Proposed Run-in/Out at Kam Tai Road

Site: Lot 130 RP in DD 110

(Response to HyD's Comments)

Applicant's Point-by-Point Response to Comments from CE/NTW, HyD

SITE PLAN (SCALE 1:200)

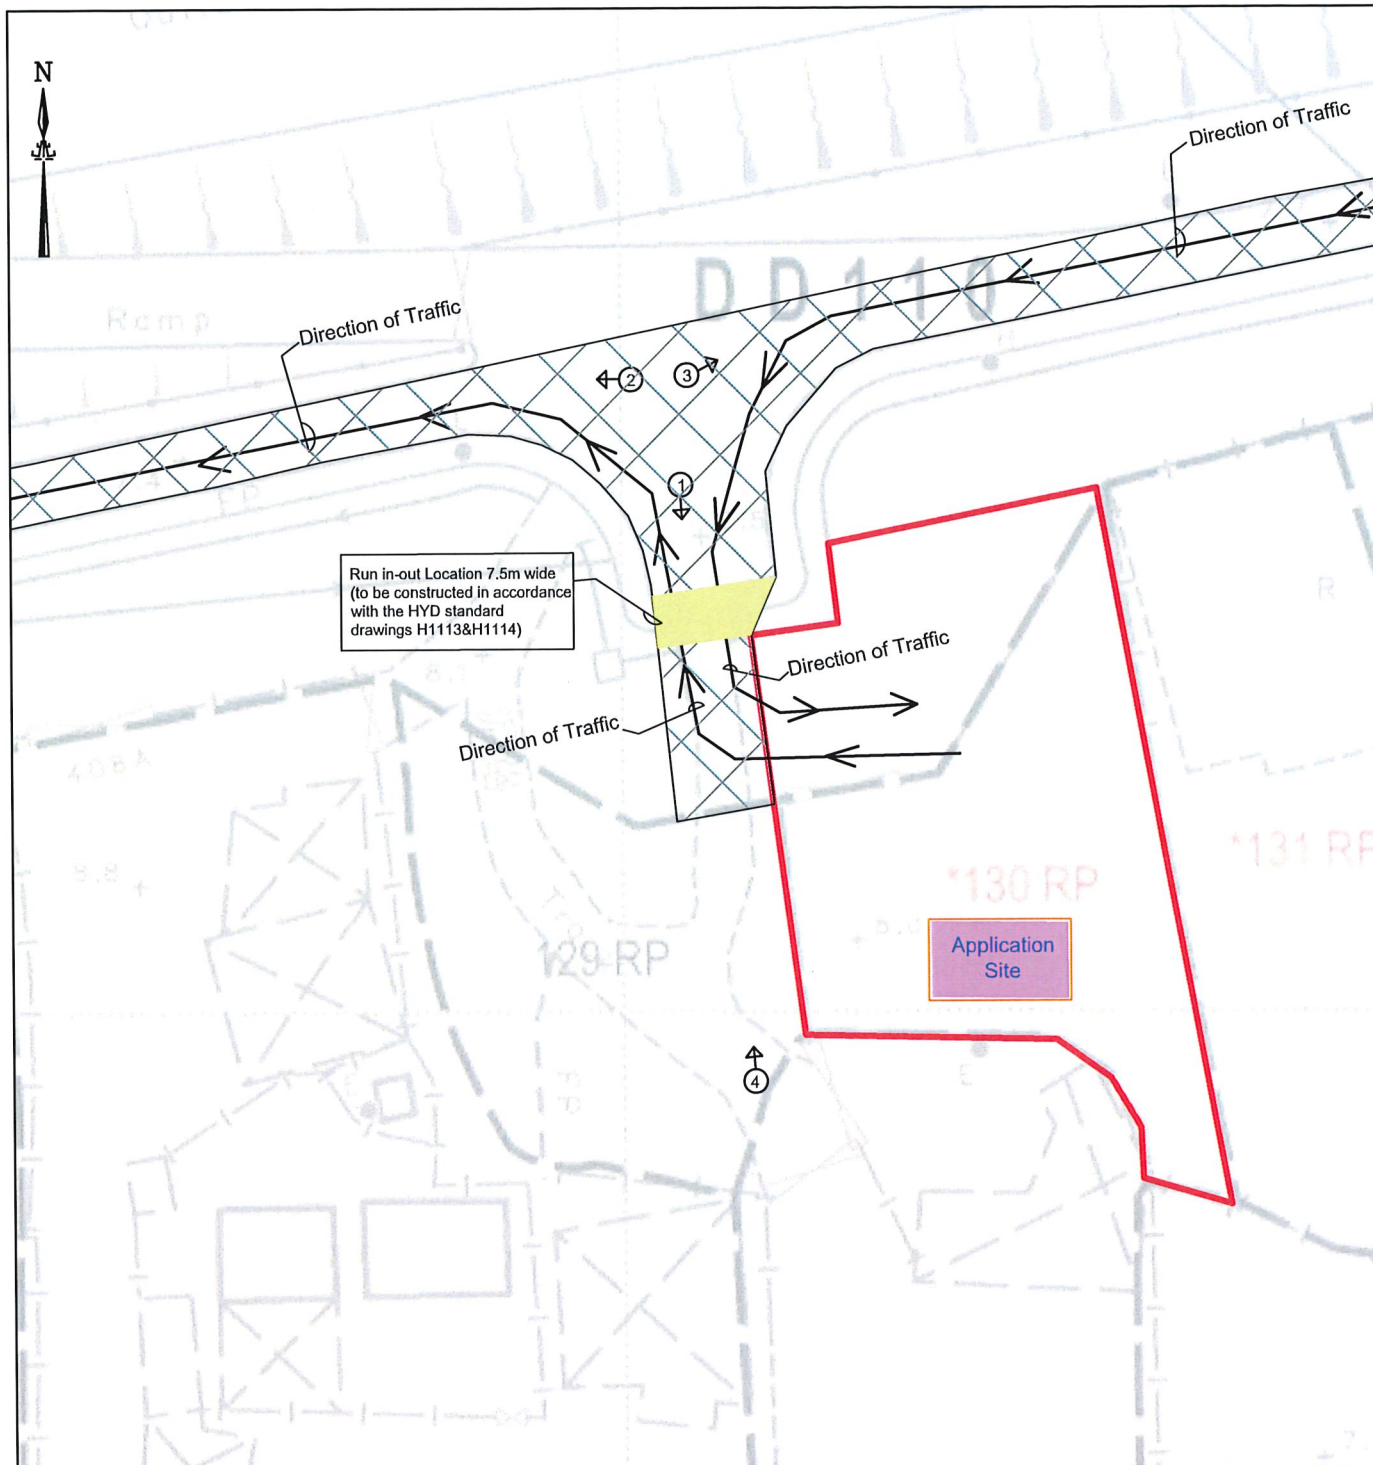
The submission is considered insufficient to demonstrate the proposed run-in/out at Kam Tai Road complying with HyD's requirements. The applicant should provide a run-in/out at Kam Tai Road in accordance with the latest version of Highways Standard Drawing No. H1113 and H1114, or H5133, H5134 and H5135, whichever set as appropriate to match with the existing adjacent pavement. Location and dimensions of the run-in/out should be indicated in the proposal for easy reference.

The applicant should also submit the details of road modification works, including modification of street furniture and road drainage if any, at Kam Tai Road for review by TD and HyD. No modification works should be implemented unless approval on the modification proposal was obtained from TD and HyD.

Noted with thanks. The submission plans have been revised accordingly to fully address the above comment. The revised plans, enclosed at **Appendix C**, clearly indicate the following:

- (a) the location of the Application Site;
- (b) the location and dimensions of the proposed run-in/out at Kam Tai Road, which has been highlighted in yellow on the revised plans, with a proposed run-in area width of 7.5 m; and
- (c) site photographs showing the existing access arrangement and the condition of the adjoining pavement along Kam Tai Road.

The proposed run-in/out shall be designed and constructed strictly in accordance with the latest version of **Highways Standard Drawing Nos. H1113 and H1114**, the references to which have been highlighted in yellow on the revised plans for ease of reference. Copies of the aforesaid Highways Standard Drawings are also enclosed at **Appendix D** for your review and record.

Noted with thanks. Site photographs illustrating the existing condition of Kam Tai Road and the location of the proposed access have been incorporated into the revised plans (**Appendix C**) for your reference. As shown therein, the proposed access is to be formed at an **existing vehicular access point** along Kam Tai Road, and accordingly, no modification to the existing street furniture or road drainage along Kam Tai Road is presently envisaged under this proposal.

The Applicant hereby confirms that the proposed run-in/out shall be constructed in full compliance with Highways Standard Drawing Nos. H1113 and H1114 to match the existing adjacent pavement. In the event that your department considers any additional road modification works, alterations to street furniture, or road drainage modifications to be necessary, the Applicant would be grateful if such requirements could be advised in writing. A separate submission detailing the proposed modification works will thereafter be prepared and submitted to TD and HyD for review, and the Applicant undertakes that **no modification works shall be implemented on site prior to obtaining the necessary approvals from TD and HyD.**
